Economic Commission for Europe**Inland Transport Committee****Working Party on the Transport of Perishable Foodstuffs****Seventy-ninth session**

ATP Handbook**Amendment to paragraph 7.3.6 of Annex 1, Appendix 2 of the ATP Handbook: Treatment of specific application cases using the multi-temperature equipment dimensioning tool****Transmitted by the Government of France****Revision****Introduction**

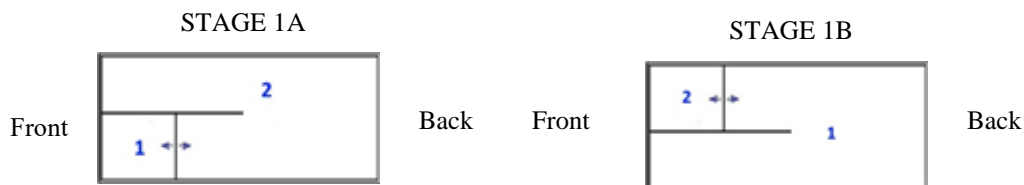
Example : case of a "J" configuration (the size of the compartments is defined by the position of the stops or markings on the walls of the body)

- The dimensioning is checked for the most unfavourable case

- The supporting document presents all configurations

The compartments are numbered starting from the front left compartment of the equipment. In the above example, according to this rule, the compartment numbers differ depending on whether the longitudinal bulkhead is connected to the front or the rear of the equipment. However, the dimensioning method does not change.

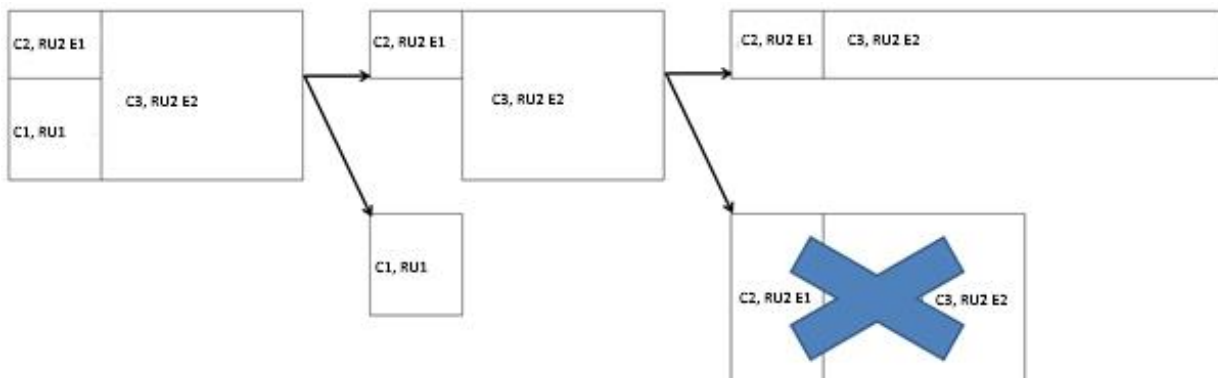
The equipment must be dimensioned in two stages. In the case below, compartment 2 (C2) and compartment 3 (C3) are equipped with a multi-temperature thermal appliance sharing the same refrigeration unit. The appliance must therefore have a dimensioning calculation and supporting documentation.

Compartment 1 (C1), with a mono-temperature thermal appliance, must be considered separately, so as to ensure that the volume of the compartment can be covered by the refrigeration unit.

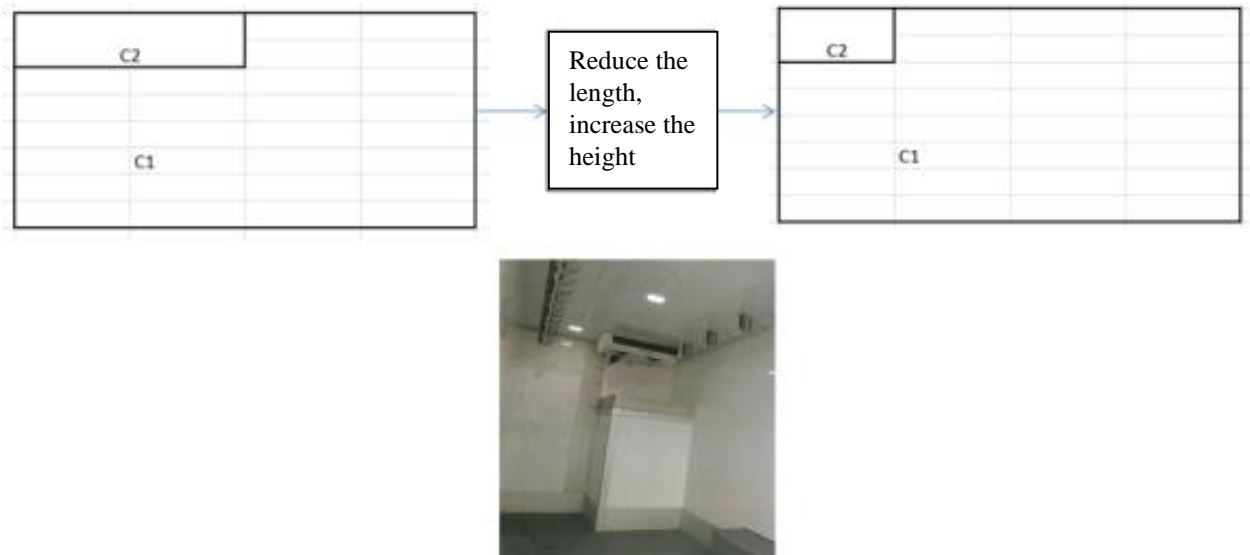
The resulting area is brought to that of the area of an equivalent parallelepiped.
